CERTIFICATE OF APPROPRIATENESS

Property: 1214 Harvard Street, Lot 16, Block 188, Houston Heights Subdivision. The property includes a historic 2,326 square foot, two-story wood frame single-family residence and a detached garage situated on a 6,600 square foot (50' x 132') interior lot.

Proposal: Alteration – Two-story side and rear addition to two-story house.

Recommendation: Denial - does not satisfy criteria 1, 4, 7, 8 & 9

NORTH SIDE ELEVATION

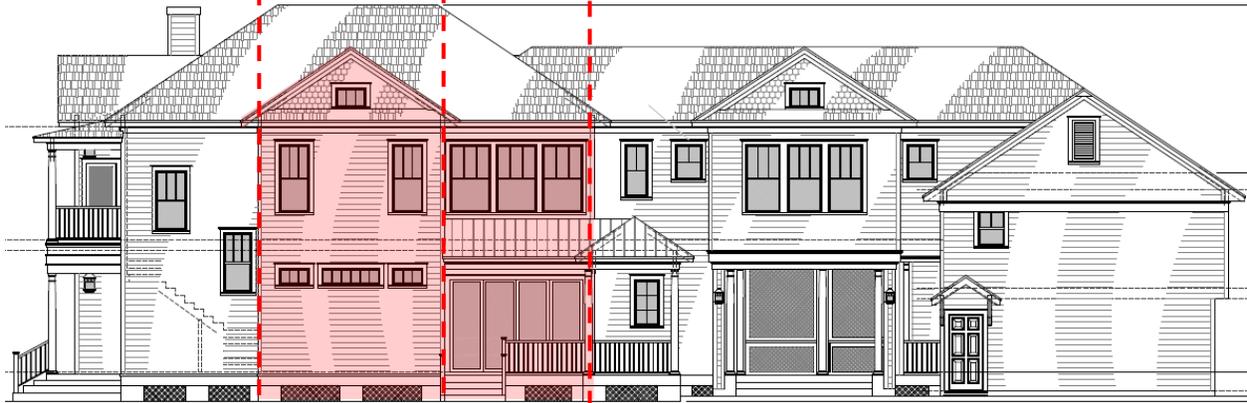
The applicant also proposes to relocate or resize numerous existing window openings, and to replace 1/1 windows with 3/1 windows, which are neither typical to the Heights East historic district nor documented as the original lite pattern for this house.

WINDOW OPENINGS TO BE REMOVED

1214 Harvard –object .- window openings and new fenestration proposed is atypical and incompatible with proportions and type of existing fenestration . Historic character of original house would be better preserved if new link between it and the existing garage block could be clearly demarcated by being set back and not seen from the right of way as a continuation of the north facade of the existing house . . .

HAHC Action: Approved with Conditions: Windows feature 1/1 lite pattern and not 3/1 lite pattern.

SOUTH SIDE ELEVATION

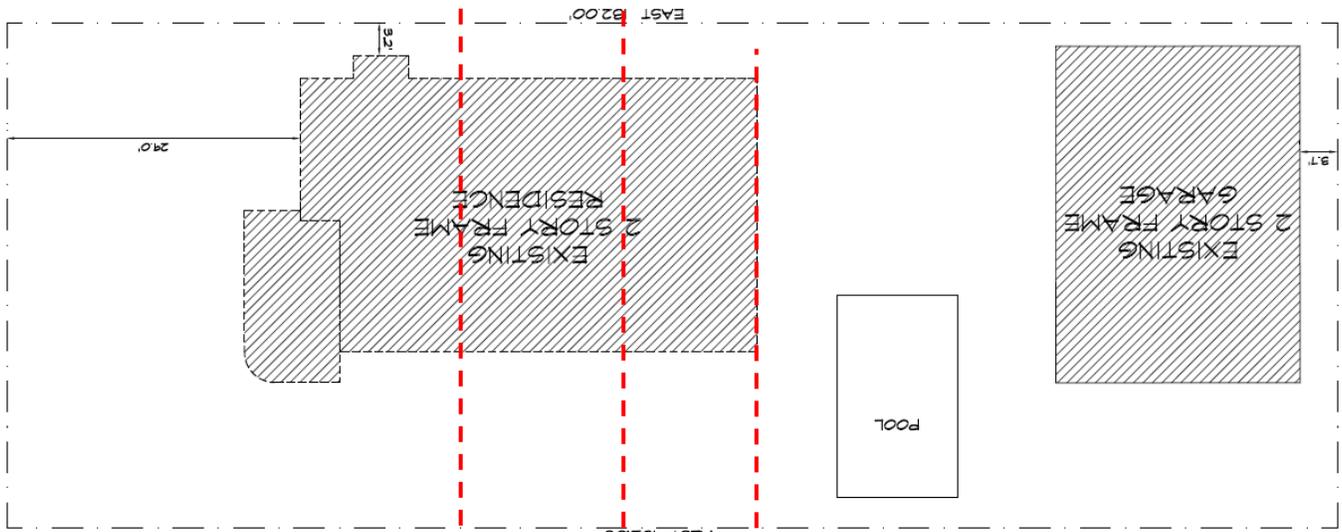
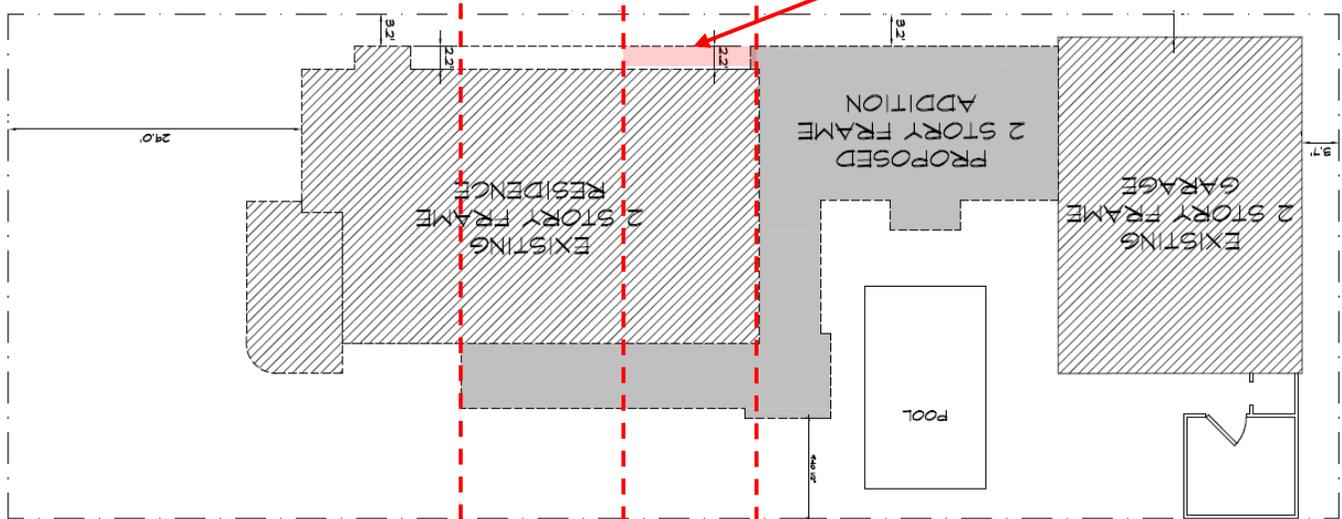
- (4) The proposed activity must preserve the distinguishing qualities or character of the building, structure, object or site and its environment;
The existing residence is characterized by its relative narrowness compared to its height. By beginning a two-story addition wider than the existing residence just 15'-10" from the front wall this distinguishing quality is eliminated. The house is also characterized by its simple rectangular footprint and hipped roof, which will be compromised with the south side bump out, the north side bump out 32' from the front wall and new cross-gable.

- (8) Proposed additions or alterations must be done in a manner that, if removed in the future, would leave unimpaired the essential form and integrity of the building, structure, object or site;
The proposed addition removes 28'-2" of the existing south wall, including 15'-10", or 57%, of the original 27' long south wall, and extends out on both sides, permanently removing a portion of the original exterior wall visible from the street as well as the distinctive narrowness and simple rectangular footprint of the structure. Although the existing siding and windows are not original, original window openings, wall structure, and the essential form of the south wall will be lost.

removal of existing historical material – see/compare existing residence right elevation and proposed right elevation), all visible from the public street right-of-way, will significantly change the existing historic character of the existing structure. Second, the resulting mass form of the proposed in-fill connection between the existing residence and the existing garage with a 2-story structure and porch will be significantly greater than the existing mass form and will not be in context with typical mass relationships for contributing structures in the HHEHD. This proposal will significantly reduce the visual priority generally afforded the existing historical structure and relegate the existing structure to a blend of multiple elements both existing and proposed. This proposal does not satisfy criteria #1, #4, and #9. I respectfully recommend this application for a Certificate of Appropriateness be denied and certainly should not be considered a “Shall Approve” submission. The significant amount of original structural material and the original form of the structure should be retained, even if the siding and windows are no longer original and further degradation of the 1910 Queen Anne style home should not be allowed.

ROOF PLAN
EXISTING

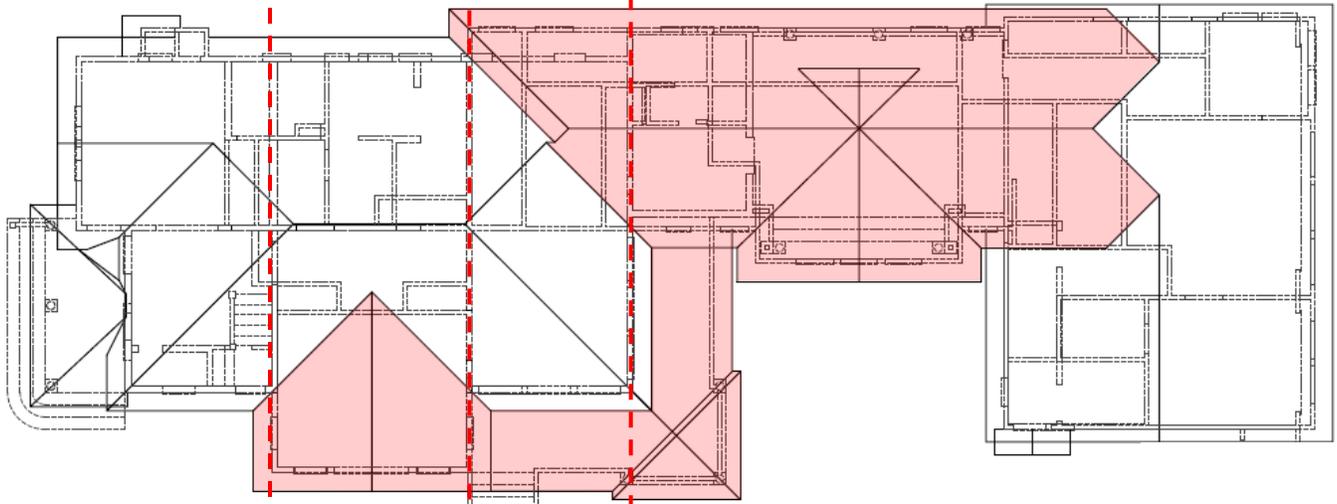
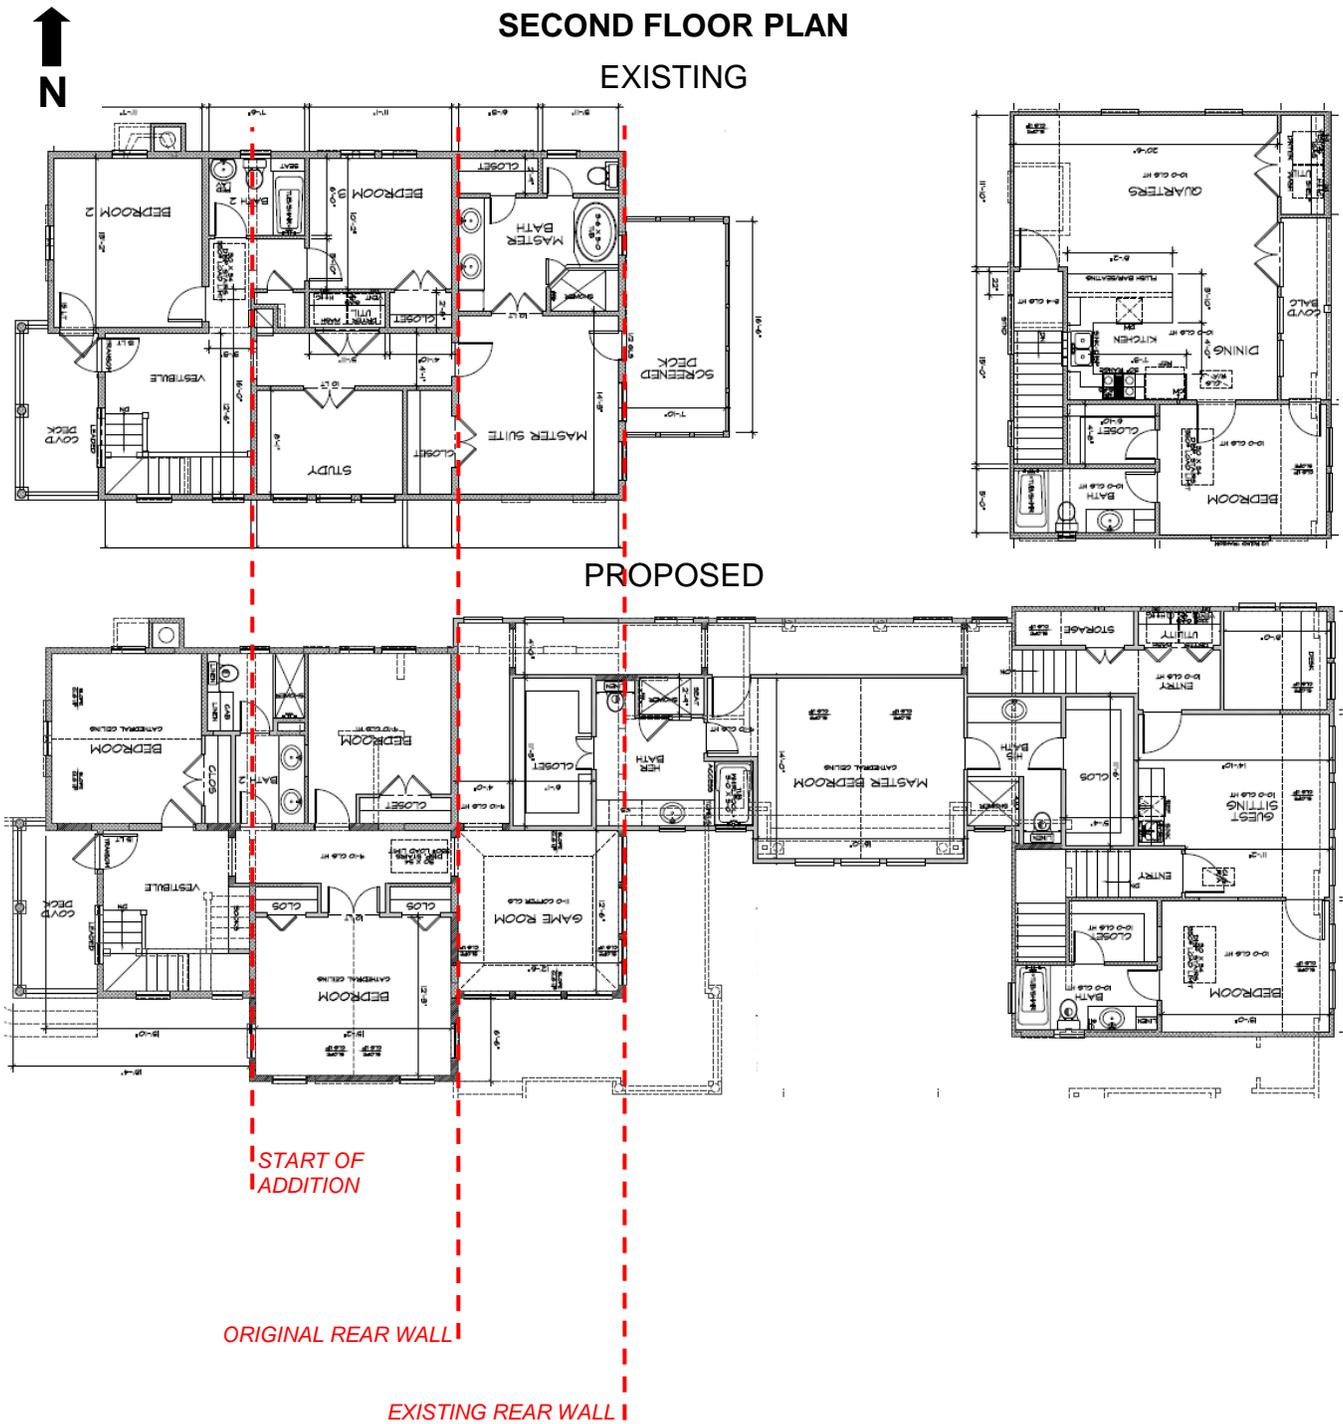
EXTENT OF NEW ROOF STRUCTURE
